EQUIPMENT SERIES: 51S

BULLETIN NO. 1

EQUIPMENT TYPE: RECEIVERS 51S-1/1F

SUBJECT: SUPPRESSION OF UNWANTED OSCILLATIONS IN LOW LEVEL AUDIO OUTPUT LINES AND ALLOW USE OF WIRING CONFIGURATION SHOWN IN FIGURE 1-2.a OF INSTRUCTION BOOK

Figure 1. Terminal Designation of Transformer T4 in 51S-().

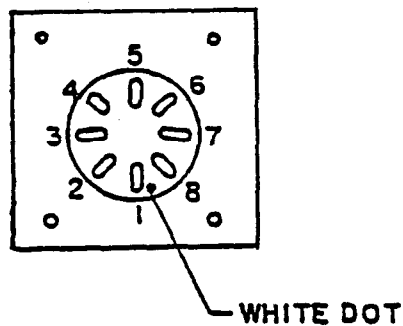
3. Refer to figure 1. Terminals 3 and 6 of T4 have two shielded wires on them and terminals 4 and 5 have only one shielded wire on them. Disconnect the wires from terminal 3 of T4 and connect to terminal J of TB9.

4. Disconnect the wires from T4 terminal 6 and connect to terminal H of TB8.
5. Connect one of the 220-ohm resistors (745-0725-00) between terminal 3 of T4 and terminal J of TB9. Connect other 220-ohm resistor between terminal 6 of T4 and terminal H of TB8.

6. Remove the white-brown-red-blue wire from T4 pin 5 and connect to TB8 terminal B. Connect the no. 22 AWG white-brown-red-blue wire (439-7057-00) to TB8 terminal B and J7, EXT RF GAIN.
